119 19th Avenue Seattle, WA 98122
SDCI Number: 3033988
September 26th, 2019

EDG 1 Board Comments

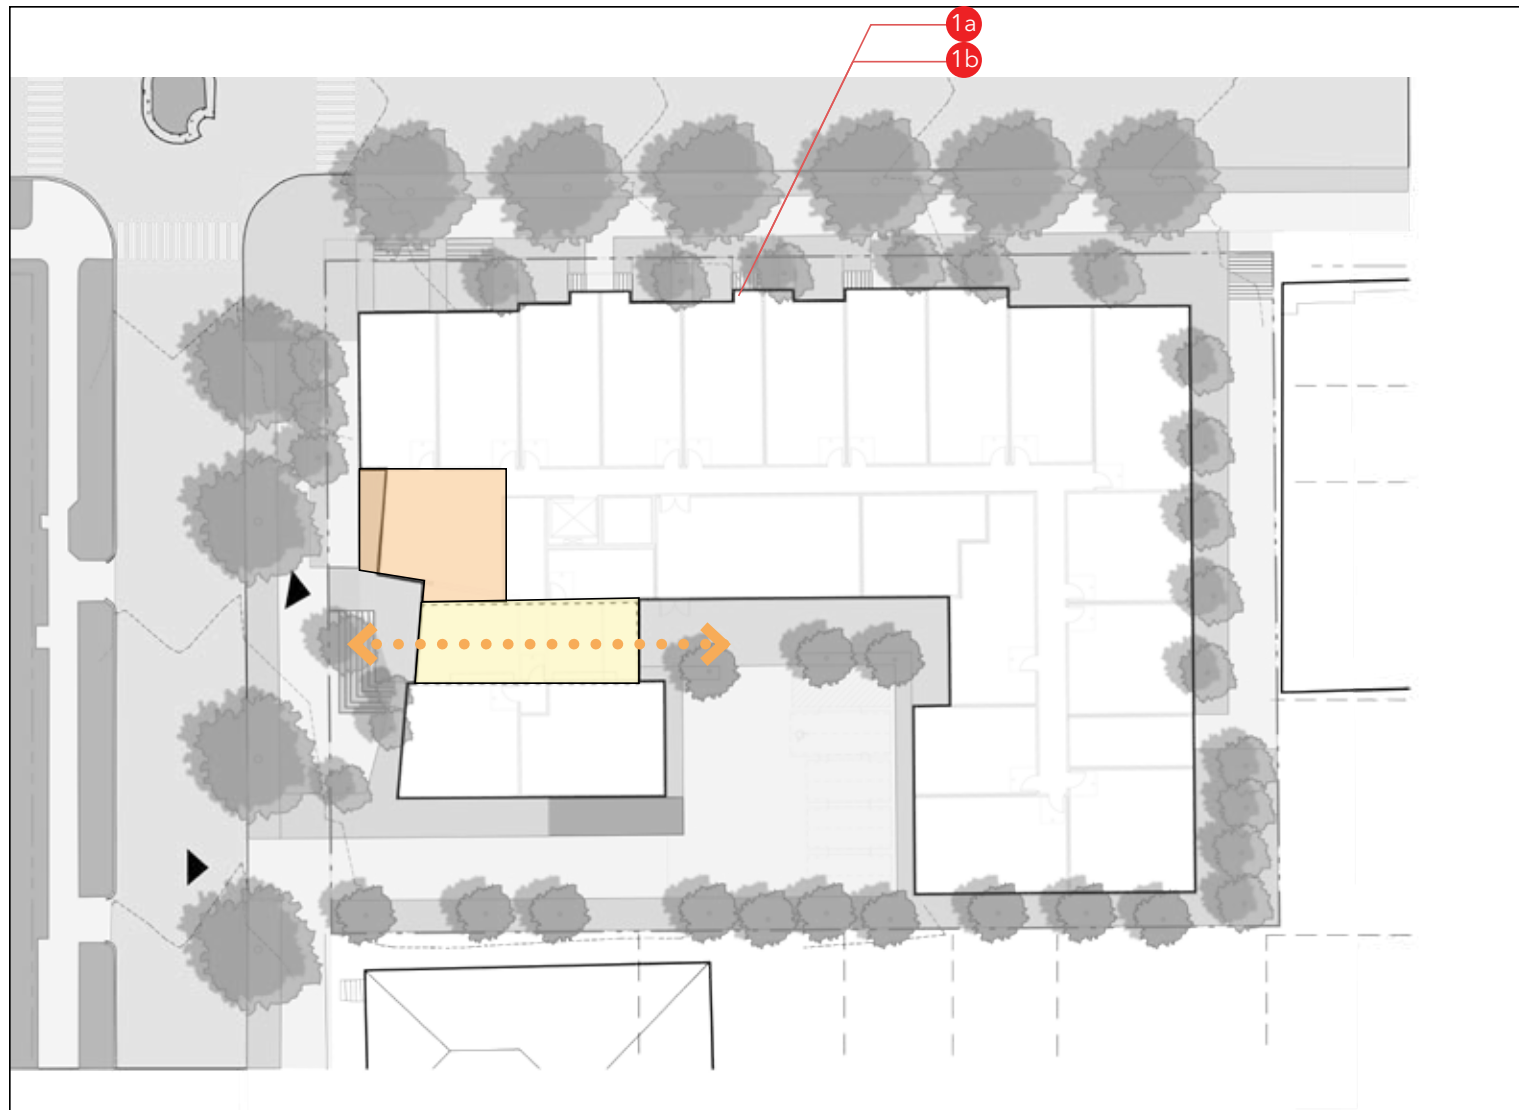
- 1a The façade of the building is busy & does not read very clearly.
- 1b The façade needs simplifying
The massing shown for the preferred option was a placeholder that indicated generic modulation along the groundplane. The applicant has provided a more advanced and integrated massing concept in the EDG materials #2 that reflects the related design guidelines, neighborhood context (pg. 20) & is mindful of addressing pedestrian scale & interface.

- 1c The SE corner of the building should be moved further back from the sidewalk to provide additional open space at the SE corner
This comment has been addressed in the revised plan. As the lobby has moved to this vicinity, the design team has set back the building to provide for bike parking, a wide stair that faces south, & an accessible ramp that also serves as a bike path. These hardscape features will include integrated seating that provide opportunities for casual interaction.

- 1d Step the building mass down at the NE corner at the intersection of 19th Ave & E Fir St.
The building massing has been reduced by 5.5' at the corner of 19th and Fir (pg.19).

- 2a The Board gave guidance to remove the 4 parking spaces located in the interior of the site & replace the parking with open space suitable for a future garden area.
The design team has removed the parking & replaced it with planting as advised.
- 2b The Board encouraged the applicant to reach out to other community groups in the Central Area neighborhood to assist with establishing a palette of materials & colors appropriate for the building.
The design team has met with the Central District LURC (pg. 4), to review the plan itself. Additional meetings will be scheduled to discuss the next suitable steps appropriate for the building upon approval of EDG #2.

- 3a The Board recommended the applicant locate the amenity space at this corner to provide greater connectivity to the street & activate the corner
- 3b The Board encouraged the applicant to explore a small retail space at the ground level
The development team was excited at the prospect of a small retail use at the corner of 19th and Fir, such as a coffee vendor. The design team worked extensively with SDCI staff to explore the viability of this, however SDCI has since confirmed this use is not possible in this zone.

- 3c The Board recommended an entry off of 19th Ave that connects with the open space/garden area in the interior courtyard of the development.
The design team has implemented this recommendation with positive results. The relocated lobby has created an opportunity for stairs, ramps and planting that engage pedestrians, which are shown on page 10, 11, 18 and 21. The accessible route to the lobby creates the need for the ramp, but we feel this can function as a useful transition element for bicycles as well as those with accessibility needs. We also see the ramp geometry influencing the lower building mass south of the lobby, emphasizing movement and fluidity.

- 3d The Board appreciated the applicant's entry design at Fir St & recommended that this area remain part of the design.
The design team has kept the entry in place as suggested.
